ADDENDUM No. 2

Municipality of Huron Shores Potomac Bridge Replacement TULLOCH Project 22-0887

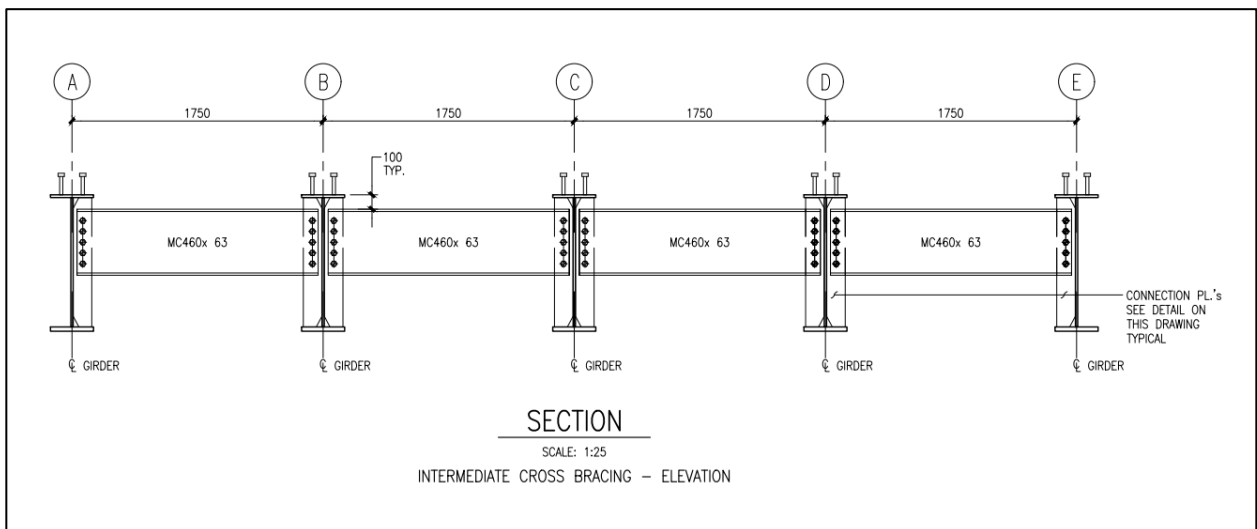
6. Clarification: The top portion of the wingwalls shall have a matching reveal built into the top portion of the wall to match that of the curb as shown in the snip it below from Dwg S4.

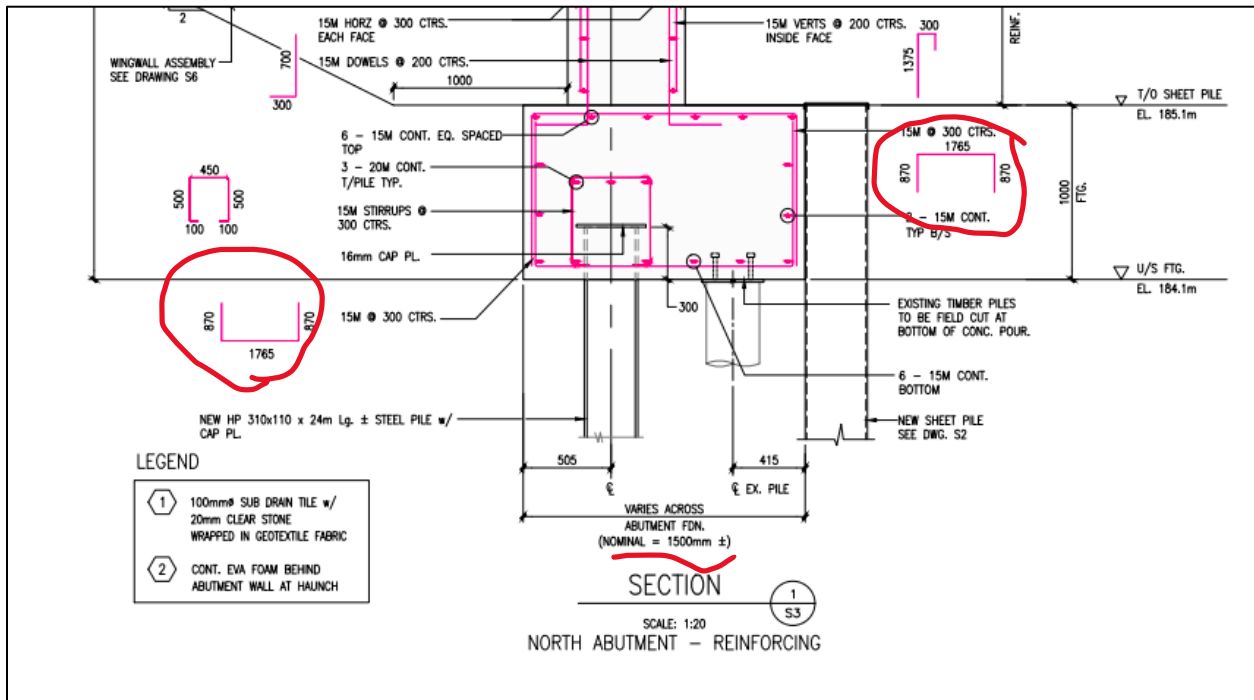
7. The end and intermediate bracing section on Dwg S7 is shown flat with a typ 100mm offset from the top flange, however this should be a target offset. The girders have varying elevations to create the cross fall on the bridge deck and the bracing elevation can be adjusted to step with the girders or the holes in the connection plates adjusted on either side of the WWF to make the bracing elevations match across bridge width (fabricators preference).
